MEMORANDUM

RE: ZP 14-0884 CA/MA 247-249 Pearl Street

Request: Conditional Use/Major Impact review of proposed redevelopment to include three story residential building with 29 residential units and surface parking to the east and south.

DATE FEB., 2014	DRAWING NUMBER C2.2
SCALE 1" = 20'	
PROJ. NO. 14103.01

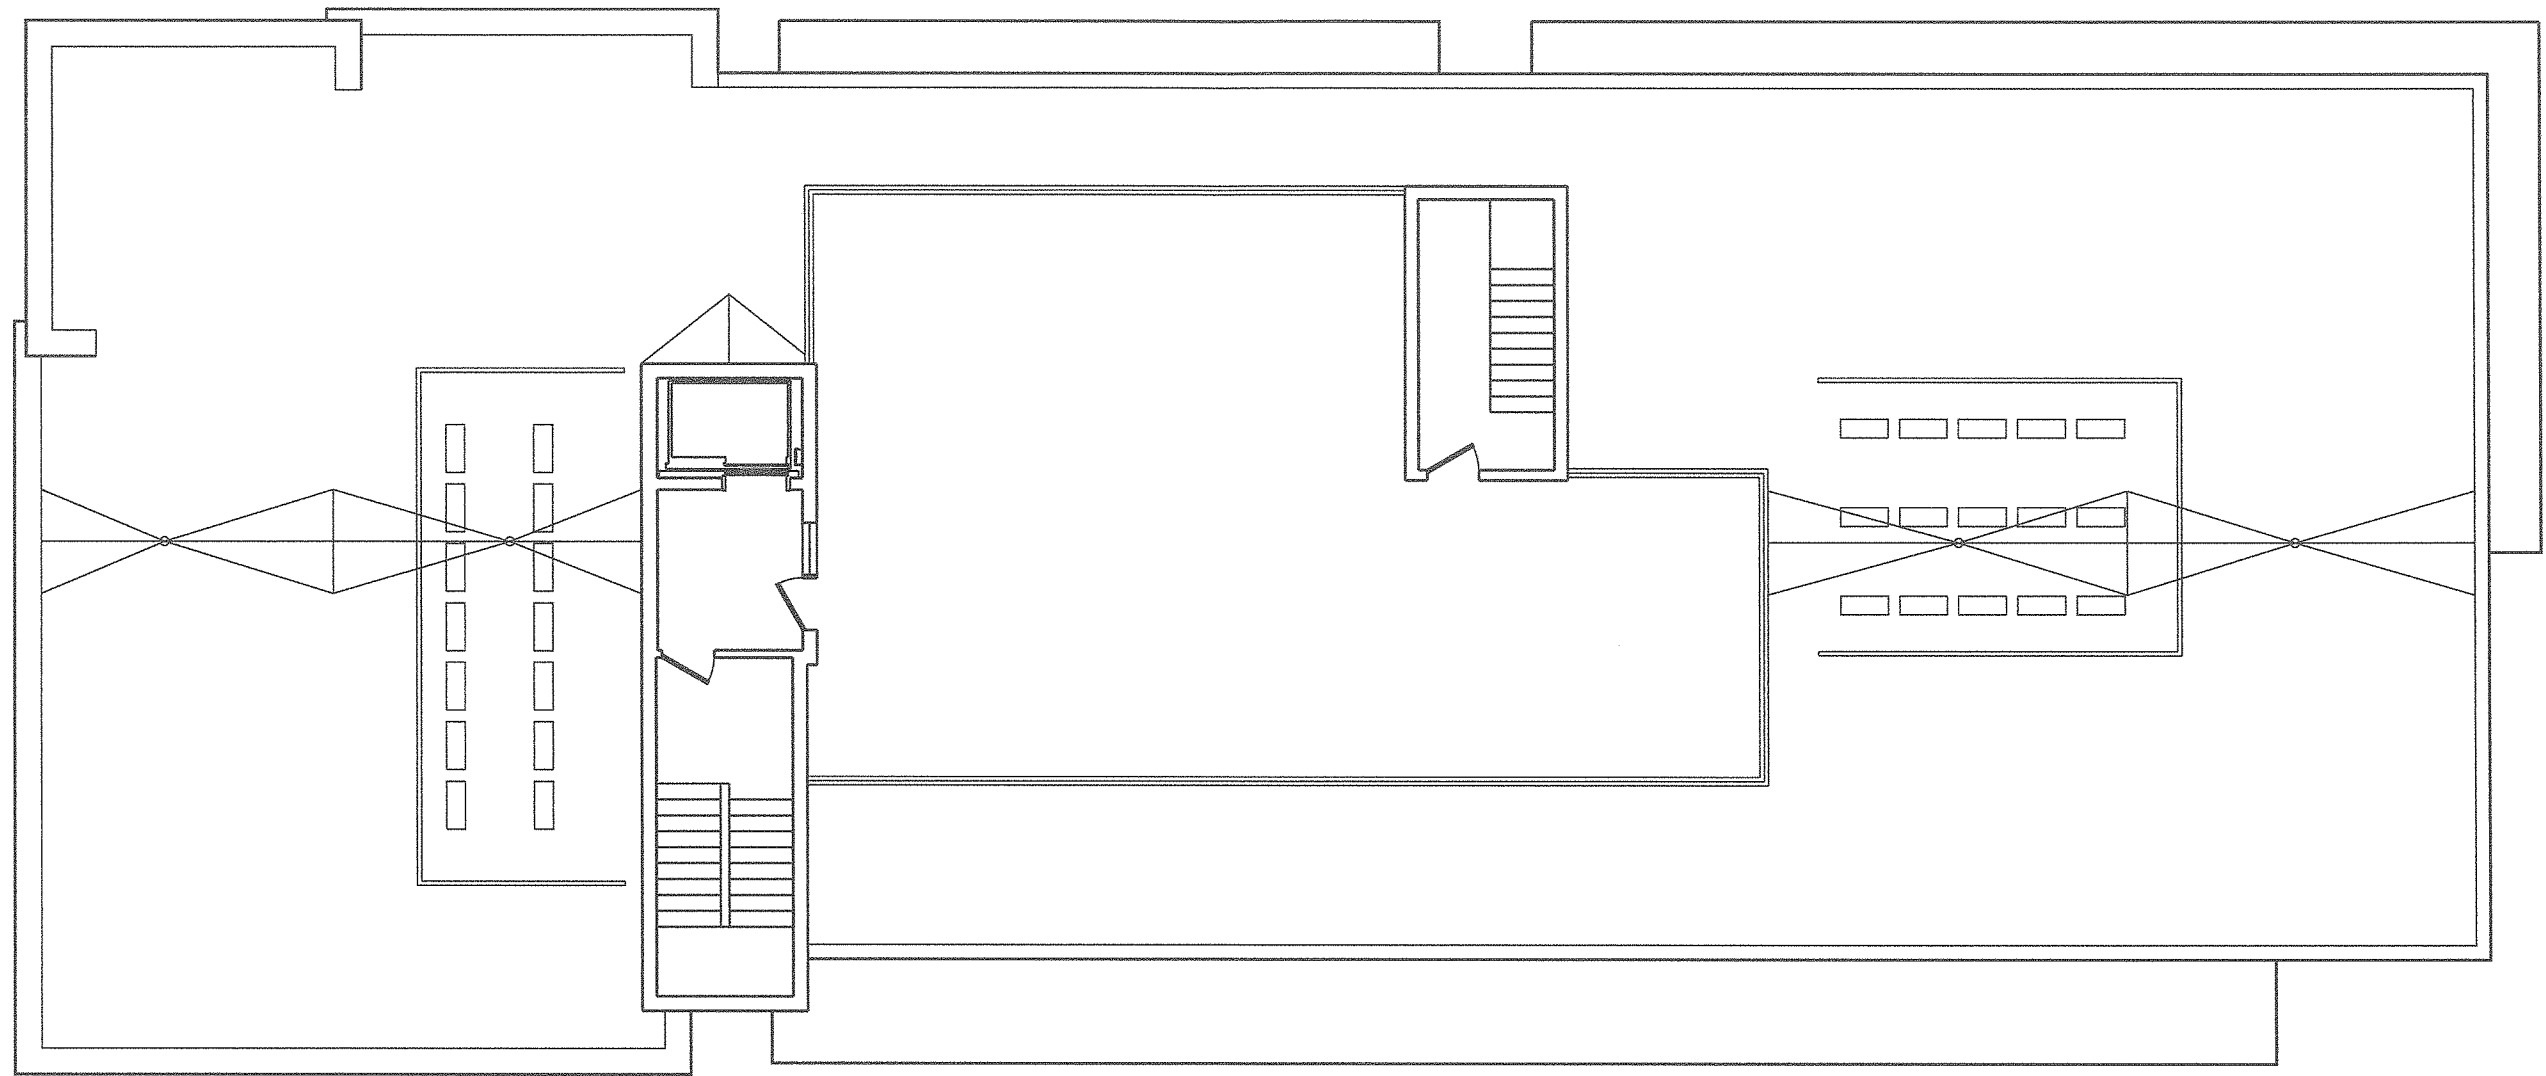
Utilities must be undergrounded. The method and design of the dumpster enclosure has been included (Plan C2.2.) While the material has not been identified, vinyl is not recommended due to the likelihood of failure.
